## TRANSPORT NOTE

To: **Wokingham Borough Council**  
From: **Iceni Projects Ltd**  
Date: **16<sup>th</sup> April 2025**  
Title: **Shinfield Park, Reading – Response to WBC Highways Comments**

4. This note provides a response to the comments provided where WBC has requested clarification or further information, with WBC comments in blue italics and Iceni Projects’ response in normal text. All agreed matters have not been replicated within this Note.

**Figure 1** Swept Path Analysis

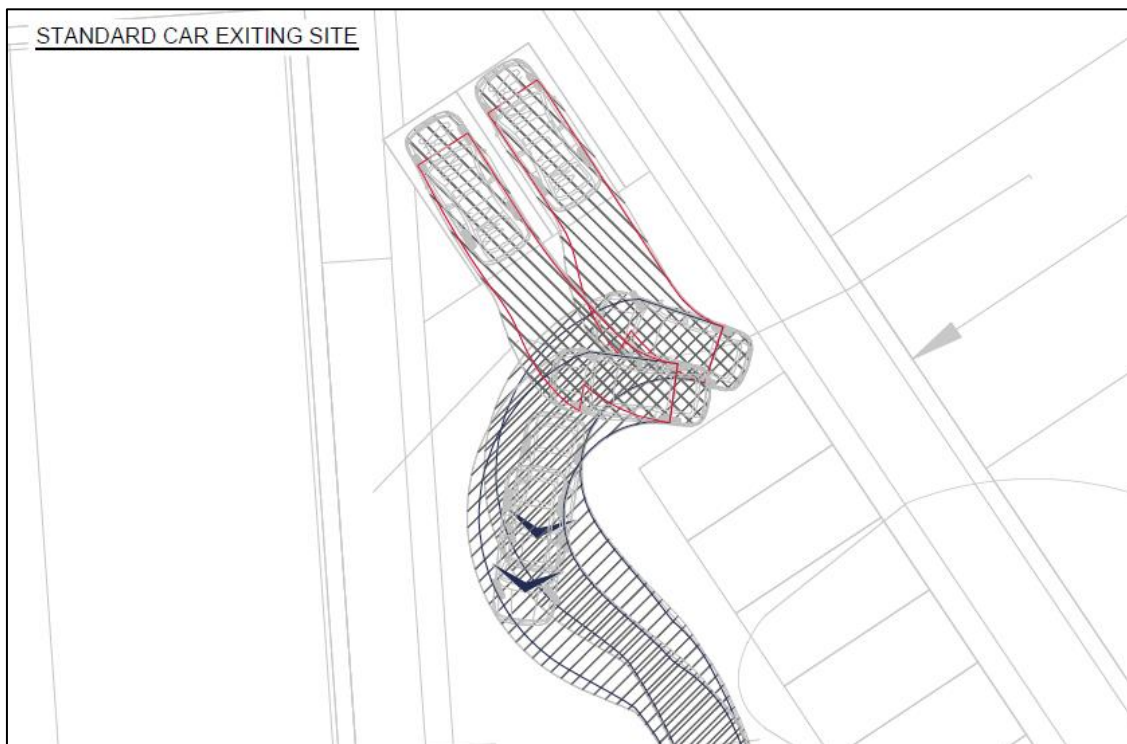
*Highways is concerned with the 2 spaces at the end of the parking area for plot 1 as egress from these spaces would require a long reversing distance. See Below.*

10. **Figure 1** and the drawing included at **Appendix A3** shows that vehicles can manoeuvre in and out of the above spaces without needing to reverse a long way and, as such, they are considered to be acceptable.

**Figure 4 Articulated Lorry Entering the Site**

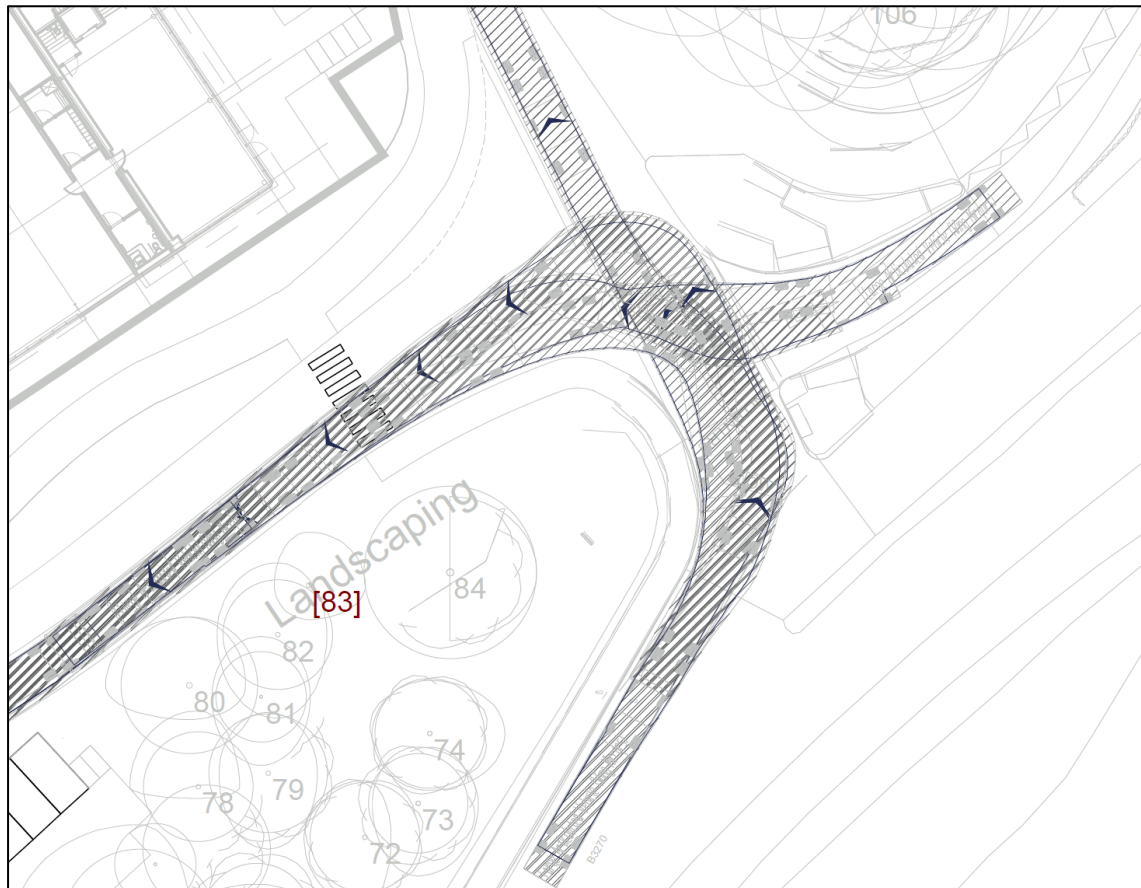
*Highways is concerned that the swept path drawings do not show the full layout of the access and egress. This will be required.*

*Highways would also need to see the swept paths of an articulated lorry turning into the main site road from Whitley Wood Lane.*

27. Drawing 02.1 Rev J shows an articulated lorry entering the site from the B3270 and Whitley Wood Lane. The manoeuvres are shown in **Figure 4**.

Drawing Title  
PROPOSED SITE LAYOUT MASTERPLAN

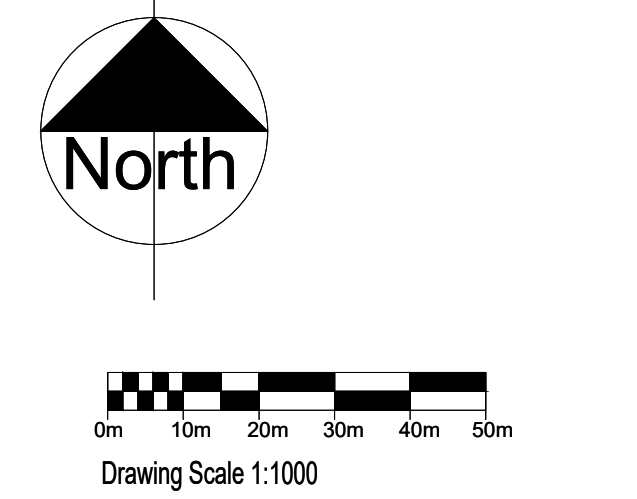
5. In response to consultee feedback and detailed design development the proposed site layout (and associated plans) have been adjusted to accommodate the following changes:

- Adjustment to the cycle shelters serving Unit 1 (now double-height facility) to allow for additional landscaping; the number of spaces has remained the same

- Revisions to the fence lines around Units 2, 5 and to the PRow/north car park gate
  - Adjustment to the traffic island at the site entrance
6. We have also picked up on a discrepancy in the floorspace figures stated within the submitted floorspace schedule which have been corrected. For clarity, these are highlighted on the revised site layout plan included at **Appendix A2**:

7. The stated floorspace has been updated having been remeasured by the architect, with the floor areas changing as shown in **Table 1**. Overall, the remeasured areas equate to an uplift of 298m<sup>2</sup>, which at 1.5% of the floorspace quoted in the TS submitted with the application is a negligible change.

SITE LAYOUT REVIEW  
(3.5T PANEL VAN)

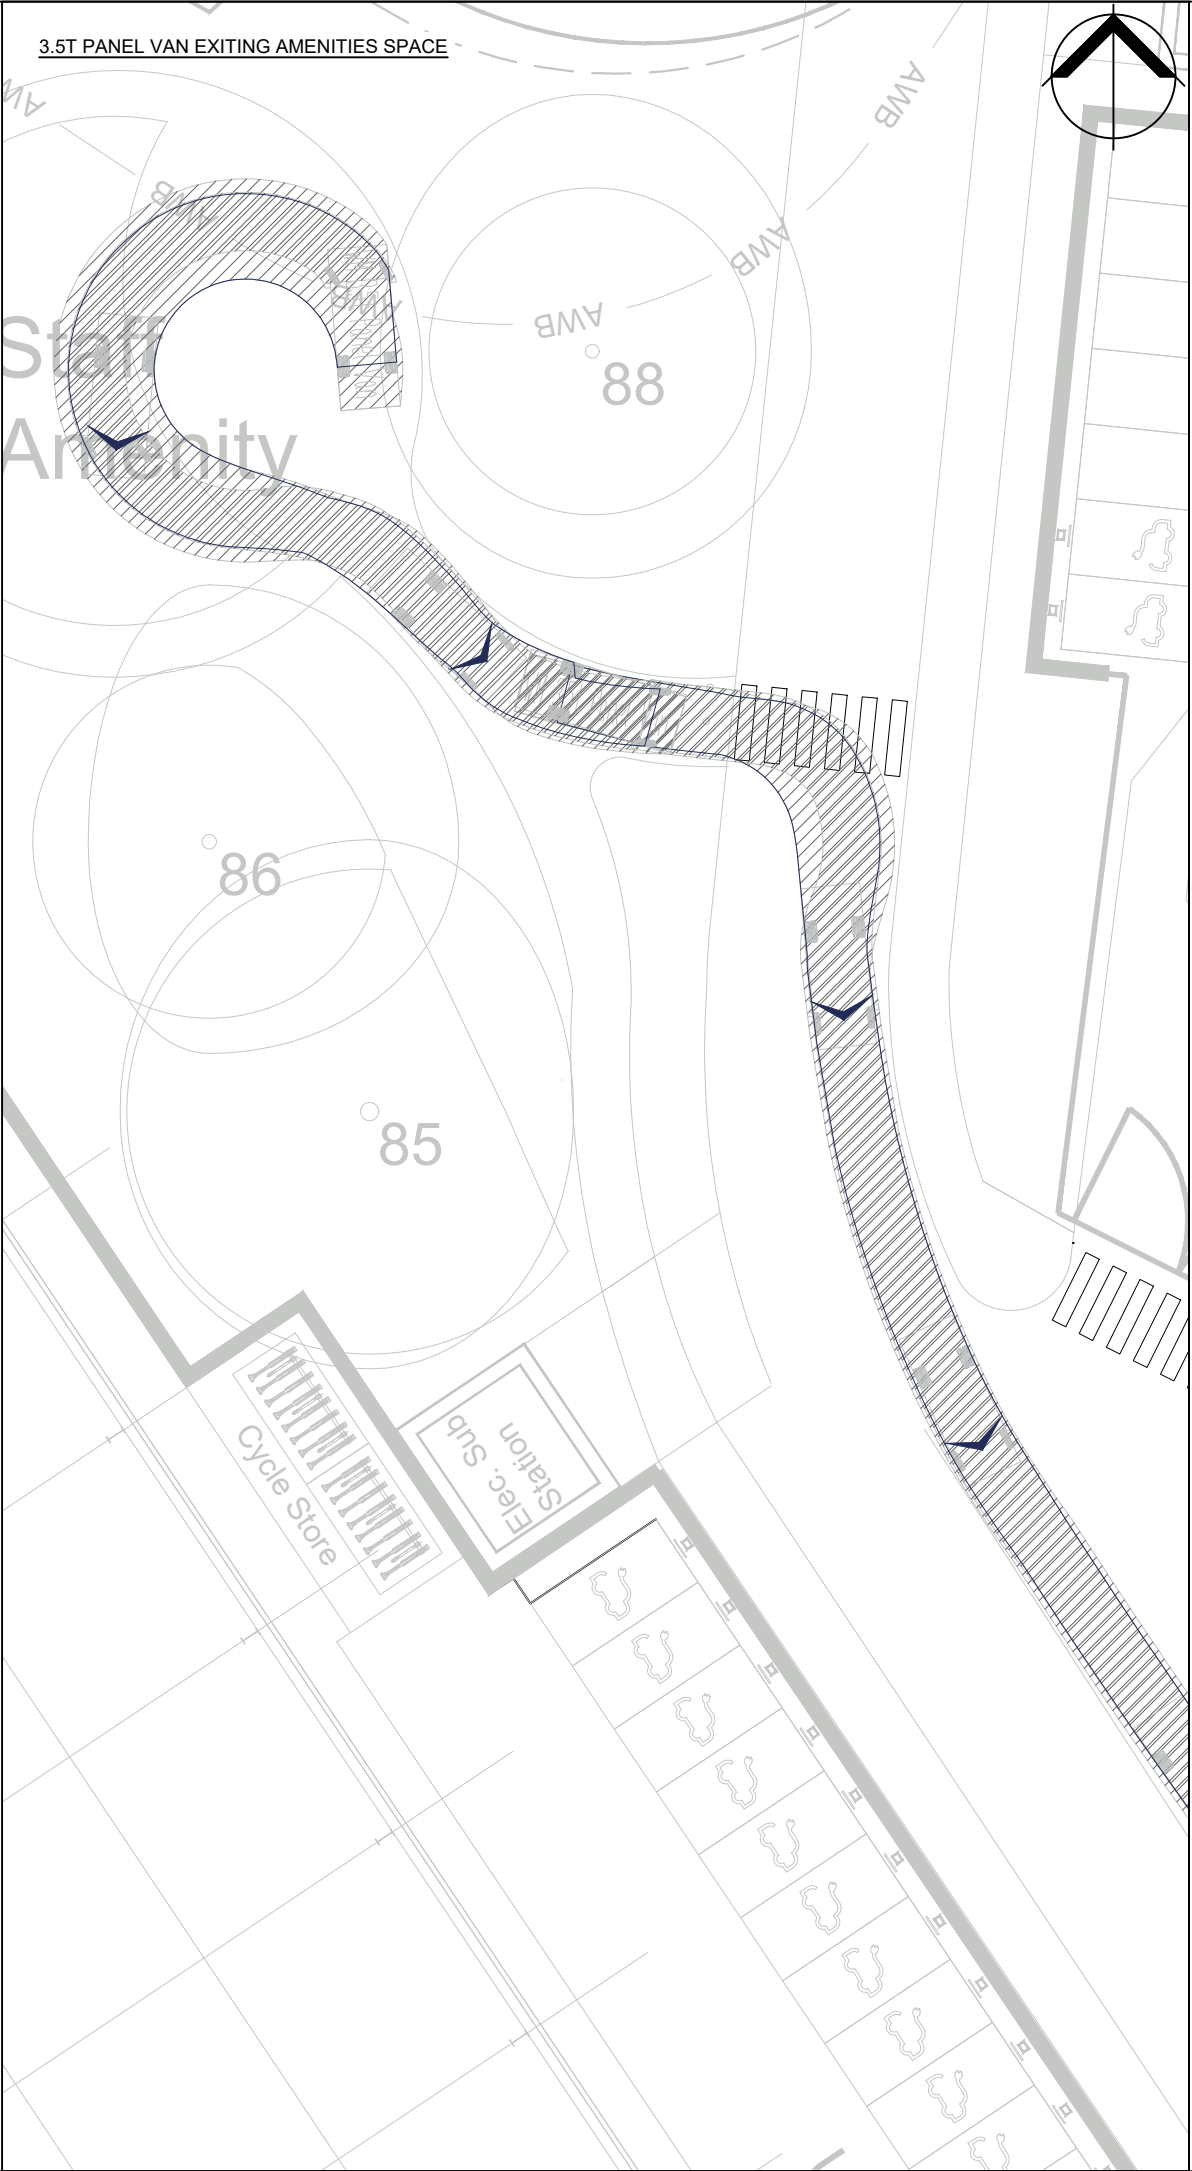
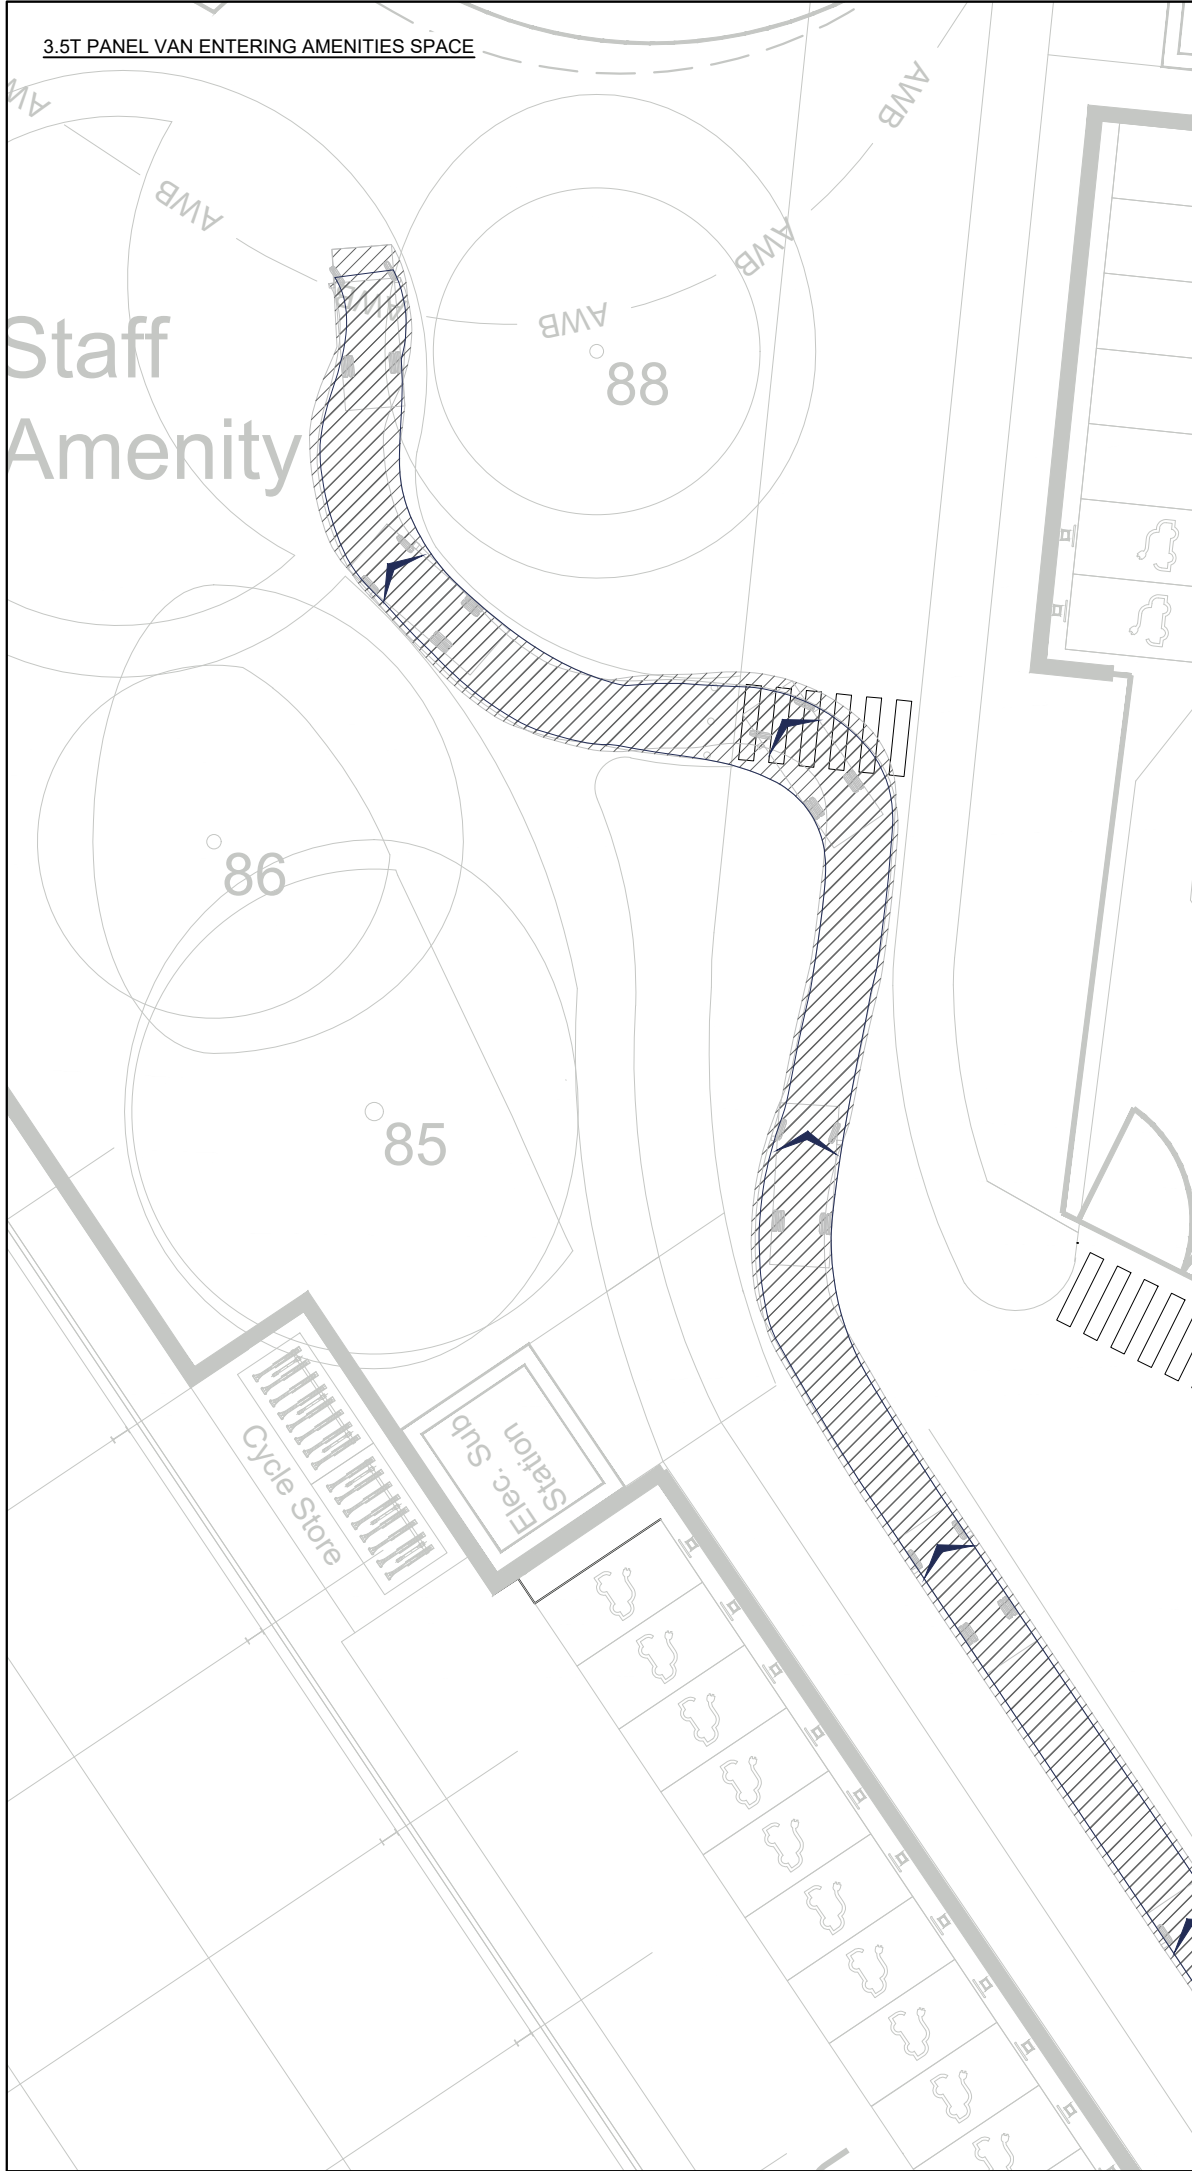
*Drawings 02.10 Rev C and 02.11 Rev A show a panel van access the amenities space which is welcome though it appears that the manoeuvring of the van goes across grass, this will need looking at.*

30. The swept path analysis has been revisited to ensure that a panel van can access the area without encroaching on the grass. The amended tracking is shown in **Figure 5** and also included at **Appendix A3**.

(OVERALL VISIBILITY ASSESSMENT)

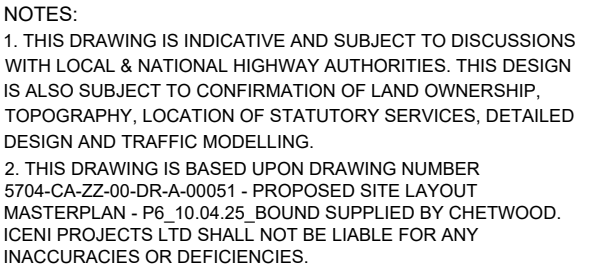
*Highways would have expected visibility splays for the accesses into the service yards and for the internal junction to have been submitted. These have not and are required.*

31. These were not included as this is a private estate road, not public highway, however, for completeness a drawing showing this has been included at **Appendix A4**. This shows that required visibility splays can be achieved, although the splay to the right for the internal priority junction is constrained by the distance to the B3270. That said, the position of this junction is the same as the existing internal layout so should be considered acceptable.
